DOCKET 50-155 - LICENSE DPR-6 -  
BIG ROCK POINT PLANT - PROPOSED  
TECHNICAL SPECIFICATIONS CHANGE  
RELATED TO PLANT ORGANIZATION

CONSUMERS POWER COMPANY  
Docket 50-155  
Request for Change to the Technical Specifications  
License DPR-6

Figure 6.2-2

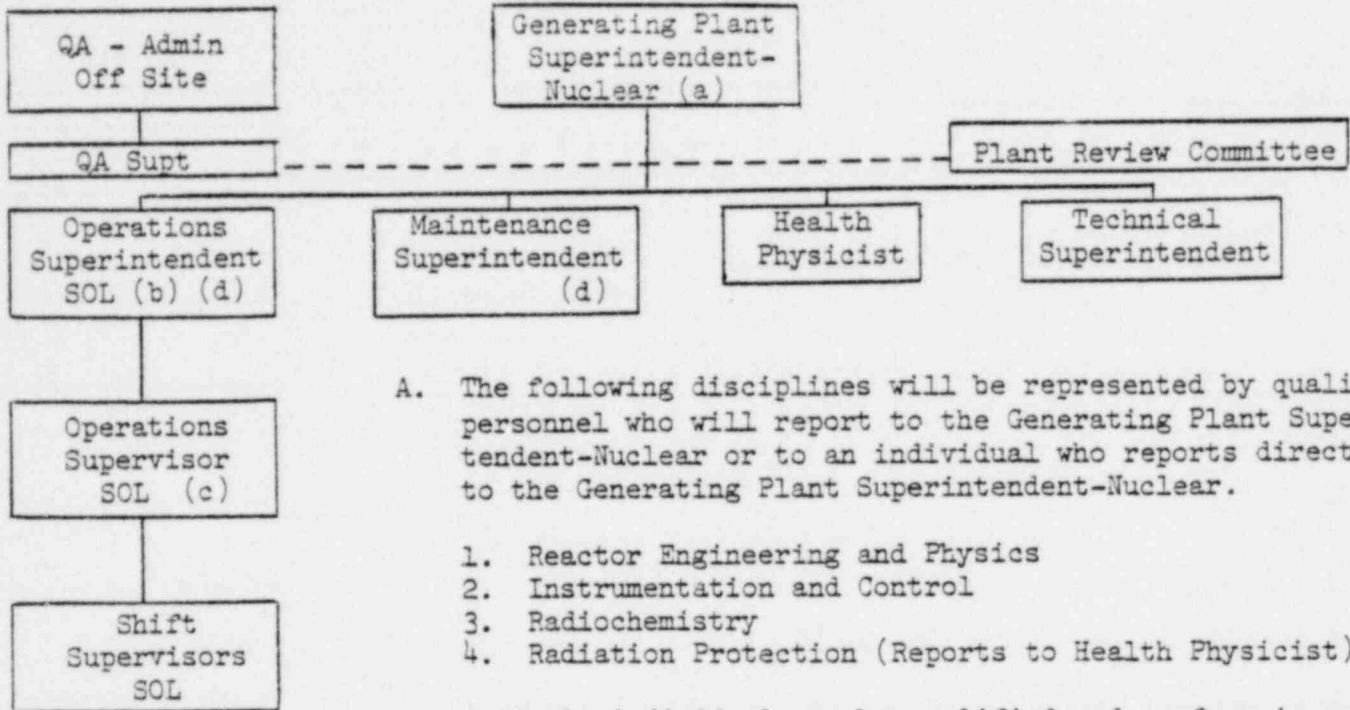
A. Replace existing Figure 6.2-2 with new Figure 6.2-2.

The purpose of this change is to bring Figure 6.2-2 in line with ANSI N18.1-1971 and to provide the Generating Plant Superintendent-Nuclear with the flexibility required to efficiently operate a nuclear power plant.

A. The following disciplines will be represented by qualified personnel who will report to the Generating Plant Superintendent-Nuclear or to an individual who reports directly to the Generating Plant Superintendent-Nuclear.

1. Reactor Engineering and Physics
2. Instrumentation and Control
3. Radiochemistry
4. Radiation Protection (Reports to Health Physicist)

A single individual may be qualified and perform in more than one discipline.

- B. The Security Force will be supervised as described in the Plant Security Plan.
- C. Quality Control Activities will be in accordance with the Consumers Power Quality Assurance Program Policies.
- D. All other personnel will report at the discretion of the Generating Plant Superintendent-Nuclear.

- (a) Responsible for the Plant Fire Protection Program
- (b) The Operations Superintendent need not hold an SOL provided he meets the other requirements of 6.3.1 of these Specifications and the position of "Operations Supervisor" is filled. Under these conditions, the Operations Supervisor shall be responsible for directing the activities of licensed operators.
- (c) This position need not be filled if the Operations Superintendent holds an SOL.
- (d) The Operations and Maintenance Superintendents' positions may be combined under one individual.
